Lower Thames Crossing

**Thurrock Council Comments on Applicant's Submissions at Deadline 1 and 2
(D1 and D2)**

24 August 2023

Thurrock Council

Plate 14.1: Orsett Cock Interchange – 2030 Do Something Forecast Queuing PM Peak (17:00-18:00)

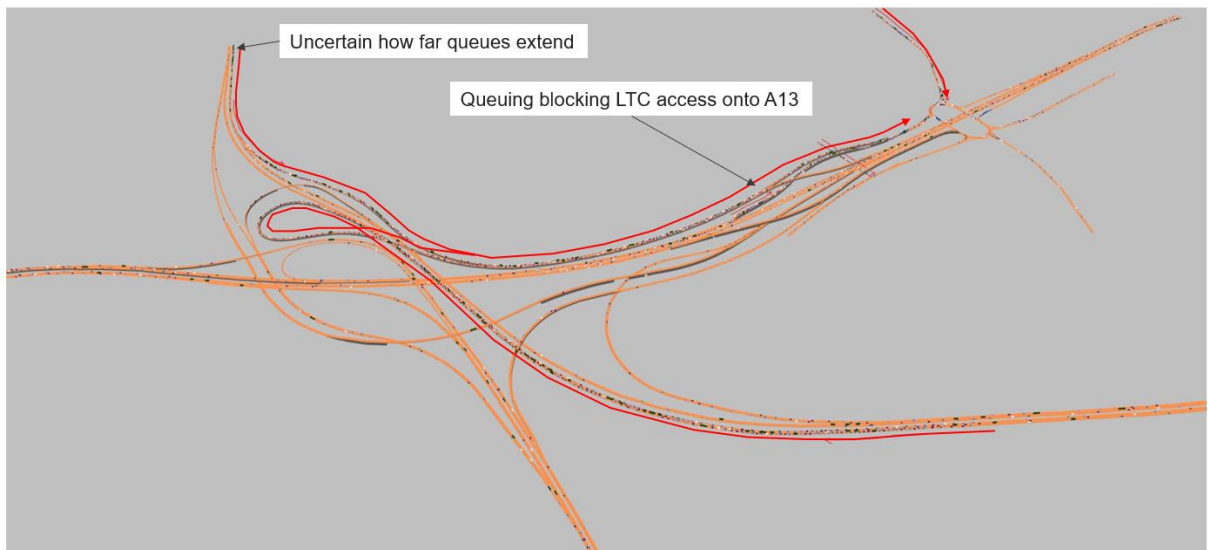
- 14.2.17 The images below (Plates 14.1, 14.2 and 14.3) provide example screenshots from the evening peak forecast models version 1.5 for the Orsett Cock Interchange Do Something models and illustrate the magnitude of queuing on the local network. The images indicate substantial queuing on both the local road network to the extents of the model on A128, Brentwood Road

(south) and Rectory Road. The images under-represent the actual forecast impacts as the latent demand should be applied to those images to represent the demand flow through those respective periods.

Figure 18.1: Updated Traffic Growth Scenarios

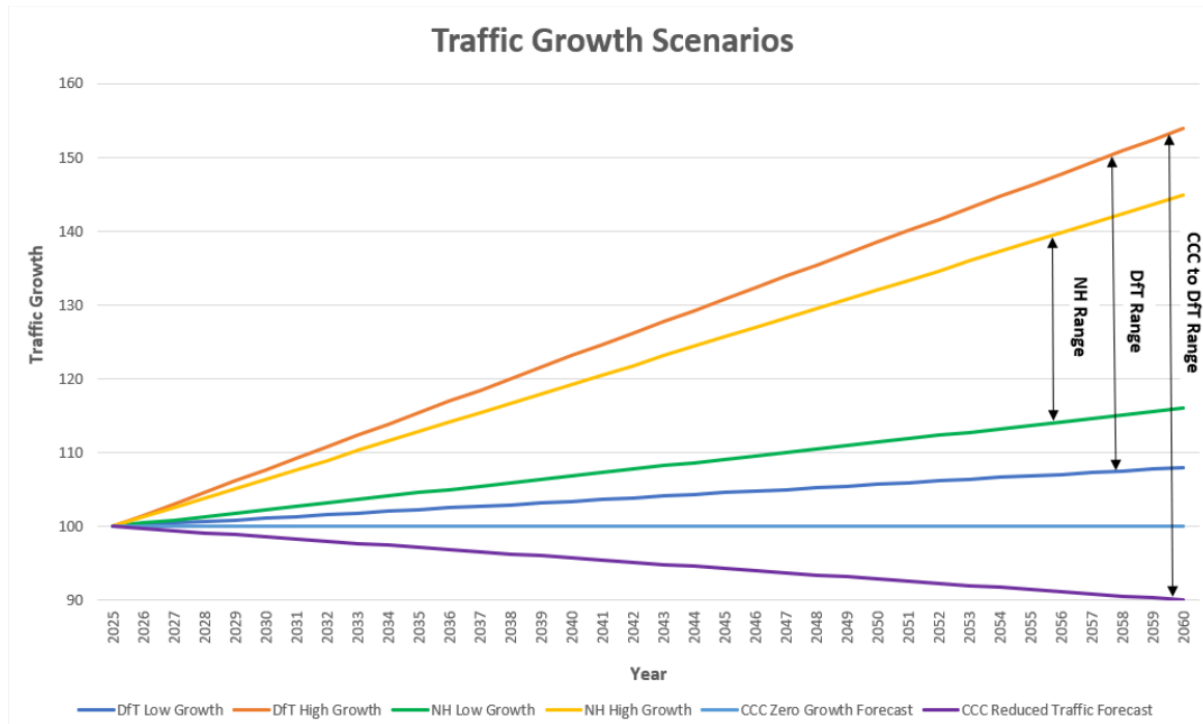
18.6.54 The implications of the current DfT advice on the short-cut method of generating a high and low traffic growth is shown on the Figure 18.1 below (as presented in Figure 8.2 of the

Council's LIR ([REP1-281](#)) and updated to include two new scenarios associated with comments from the Climate Change Committee).

18.6.55 The latest official DfT advice makes it *very likely* that the 'low' traffic growth test would almost certainly lead to lower traffic forecasts. This is because the main features of the new DfT advice are:
